STAFF REPORT
COTTAGE GROVE CHEVROLET
MODIFICATION TO APPROVAL MTA 1-22
4,200 SF ADDITION TO VEHICLE SERVICE CENTER
March 16, 2022

MEMO

Subject: ENGINEERING COMMENTS FOR SDR 1-22 (2775 ROW RIVER ROAD – COTTAGE GROVE CHEVROLET)

A000

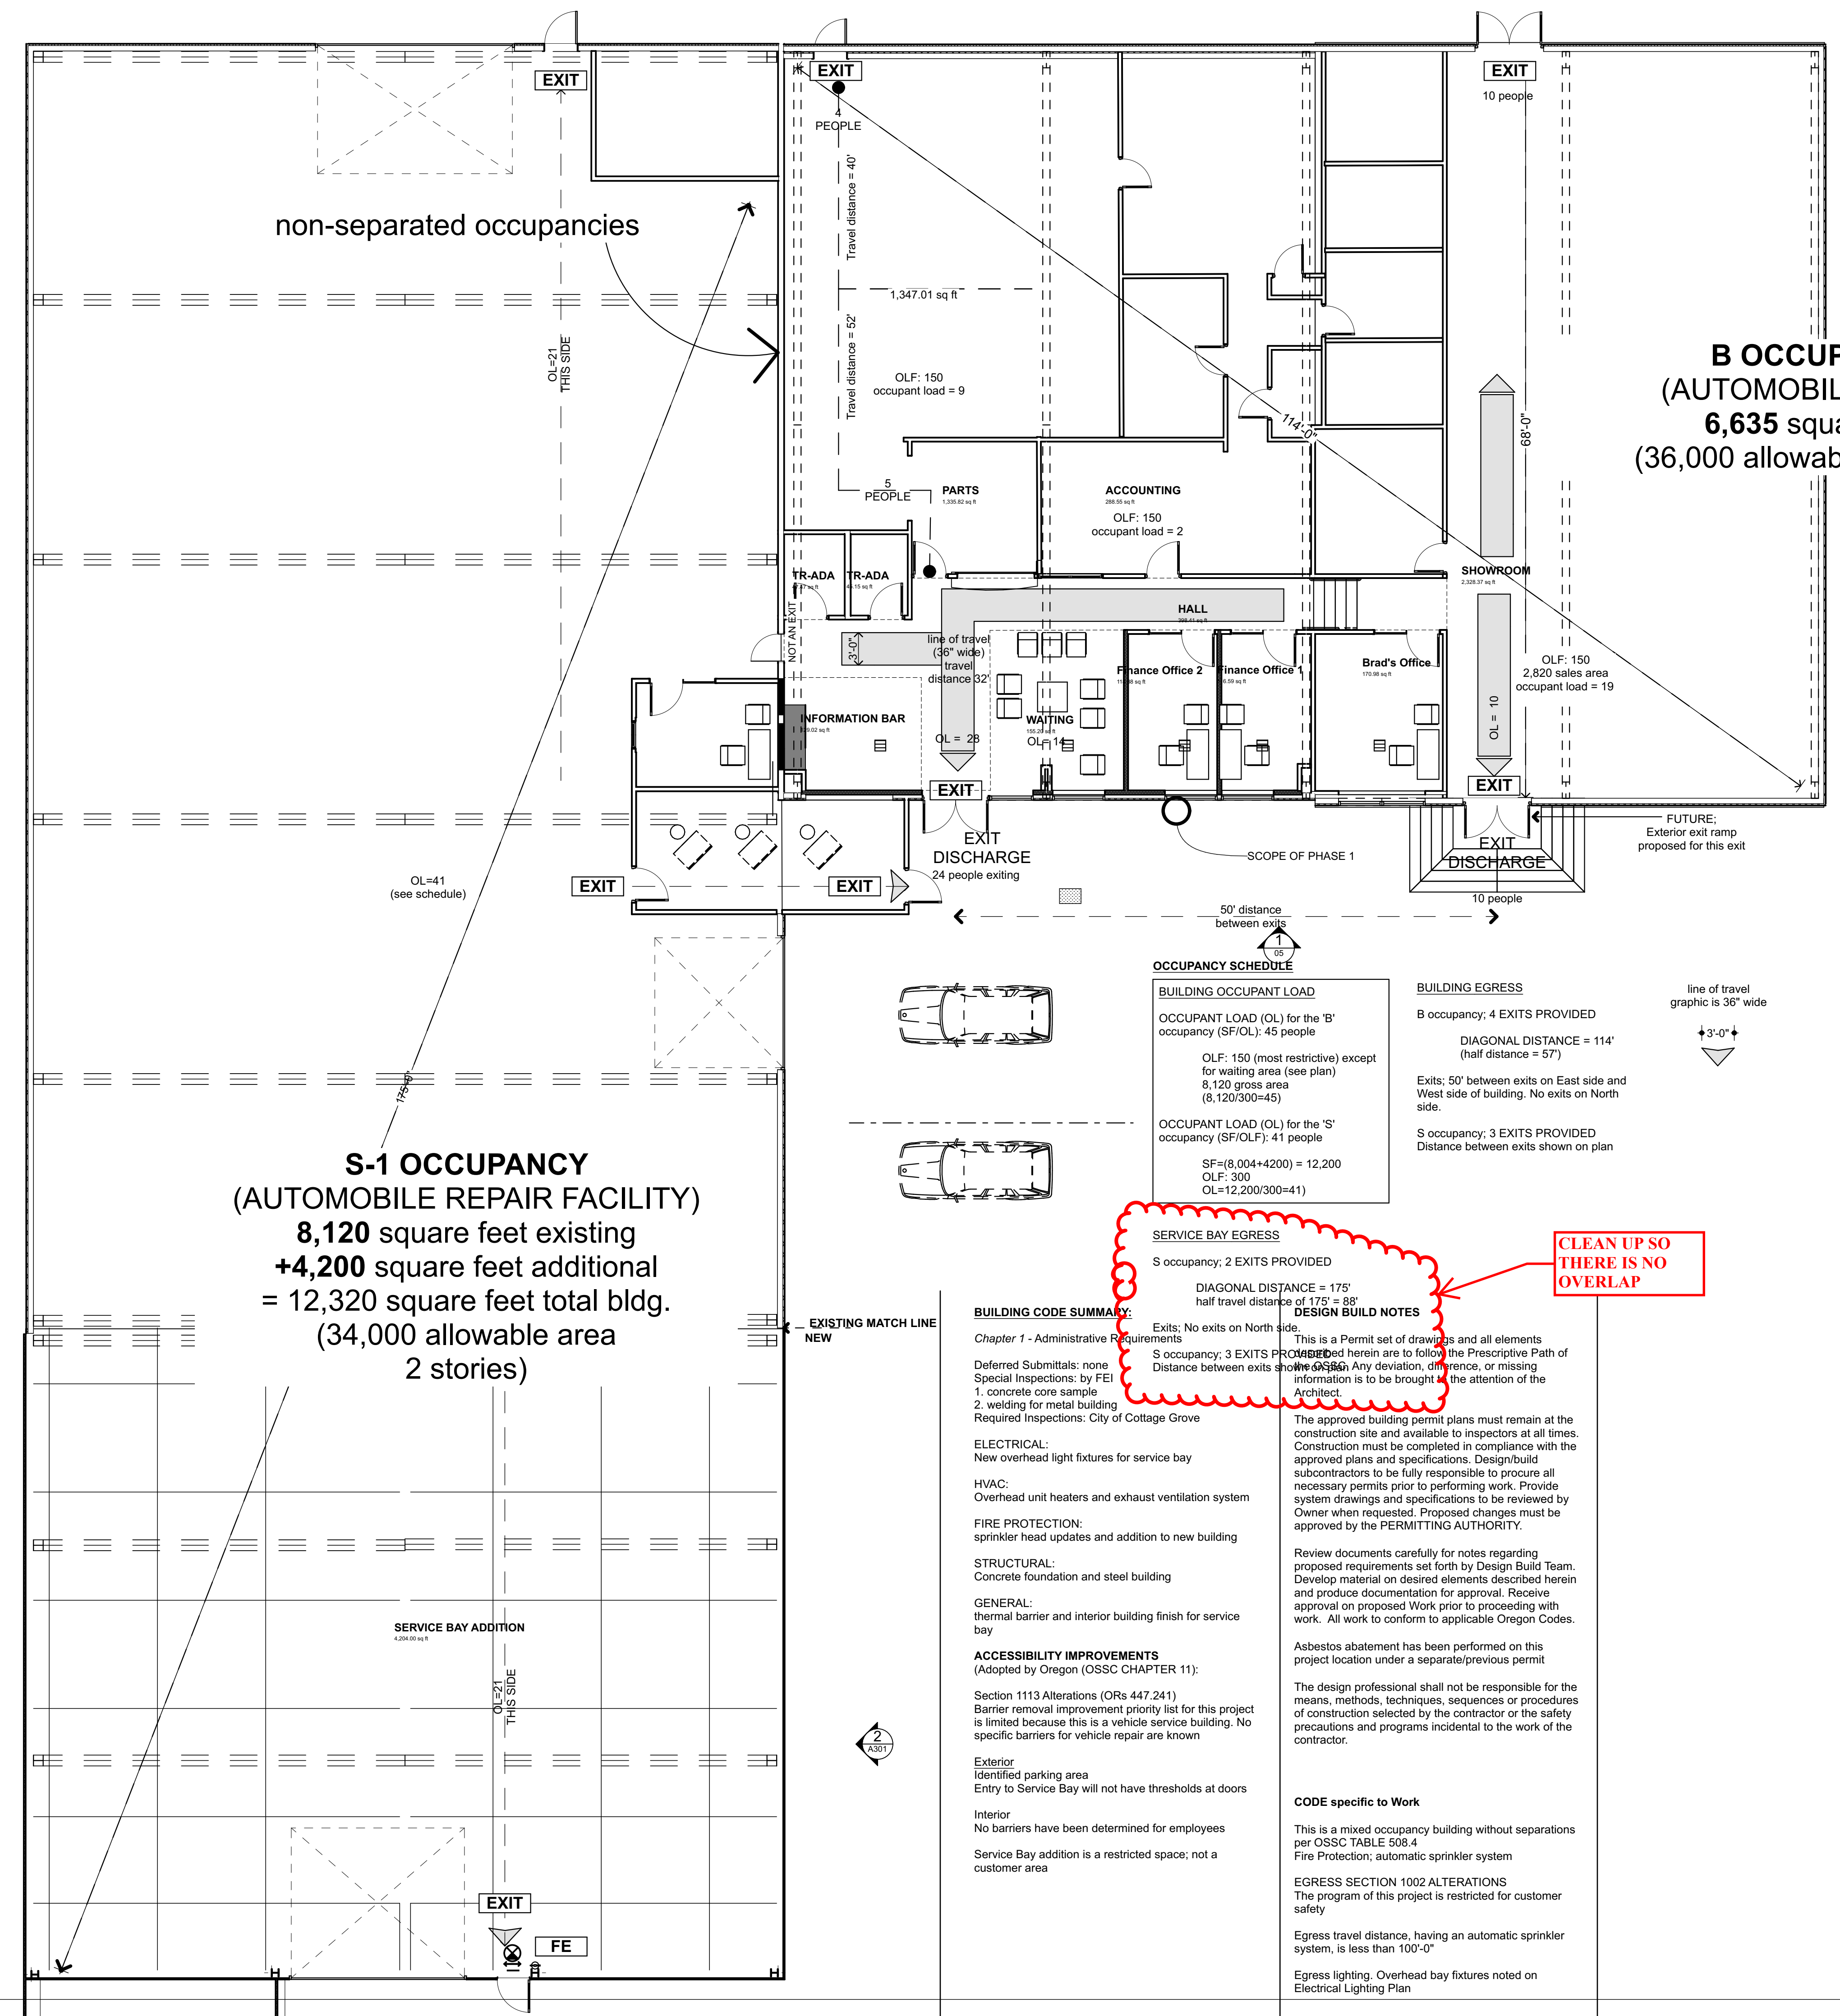
- Traffic control shall be in accordance of the Manual of Uniform Traffic Control Devices for all work performed in the public right-of-way.
- Developer will be responsible for payment of all system development charges and design review and other associated fees.
- Sheet A000 under General Refences states a 2009 edition. Is this the most current edition?
- Sheet A100 near the Building Code Summary and Design Build Notes, there is some overlapping text. On the building permit plans, it would be nice if this was corrected.
- Sheet A105 – The model number on the separator note does not match the model number in the detail. Please correct.

IS THIS THE MOST CURRENT?

BUILDING CODE SUMMARY

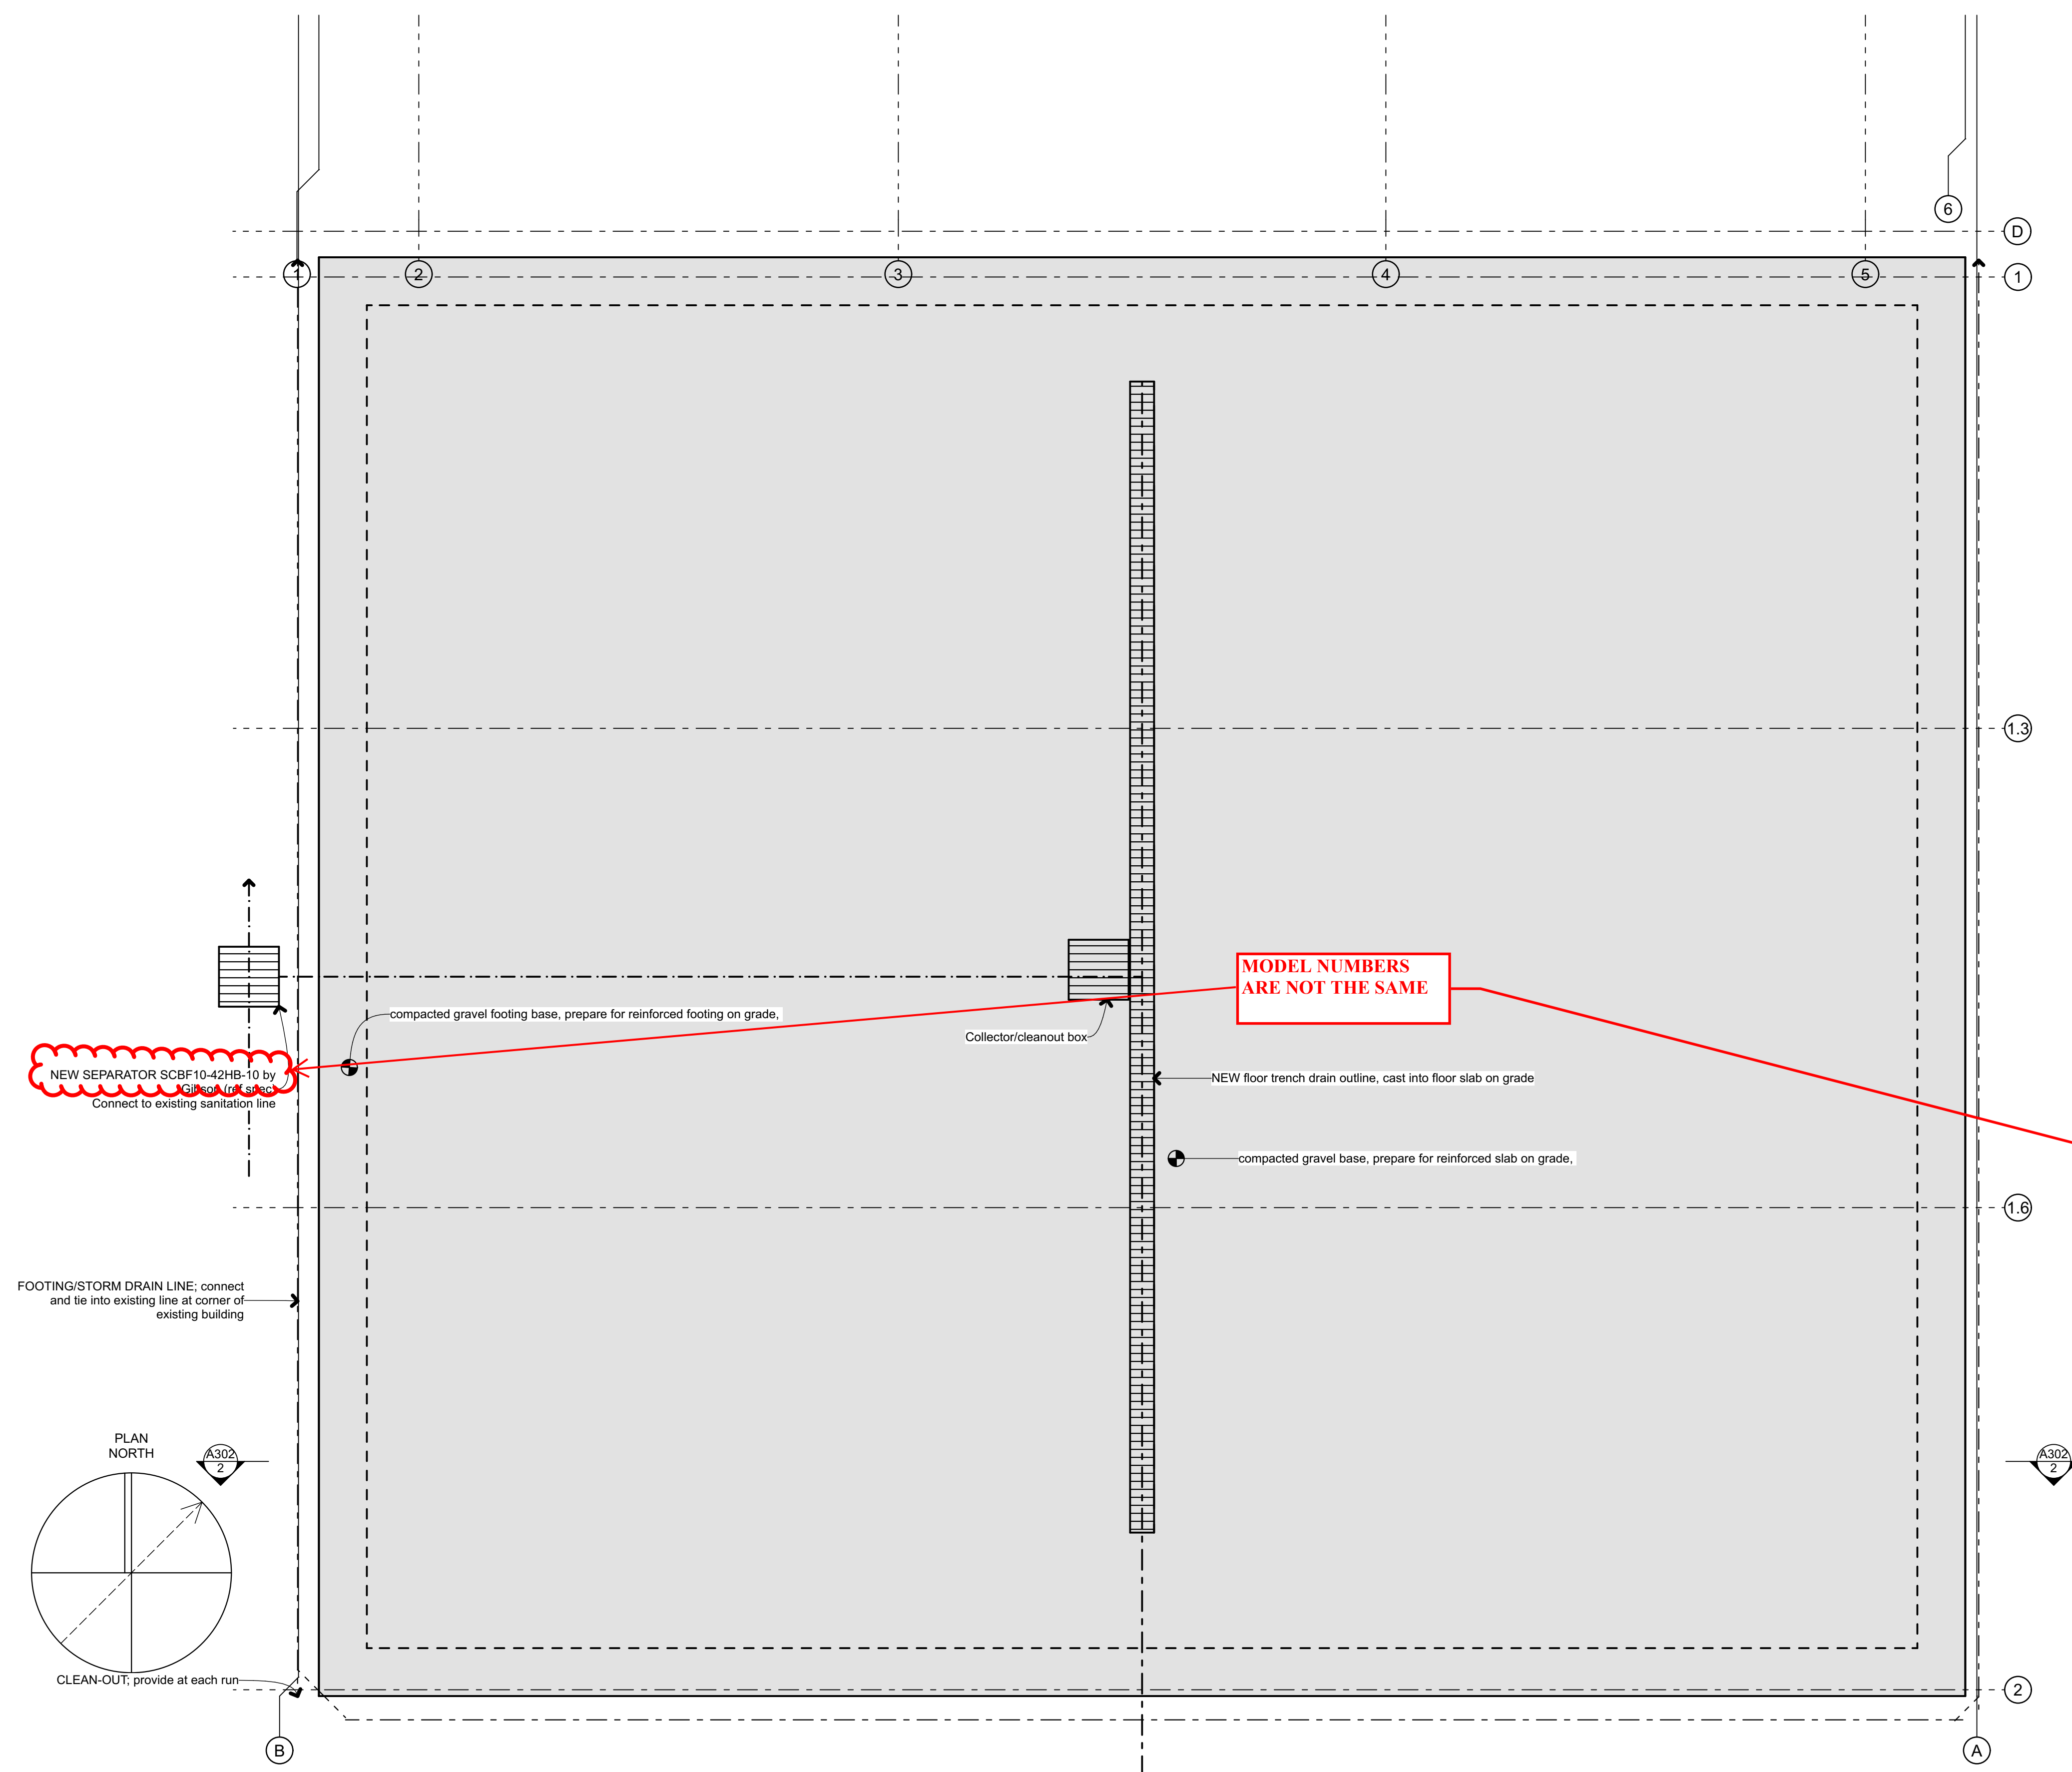
CLEAN UP SO THERE IS NO OVERLAP
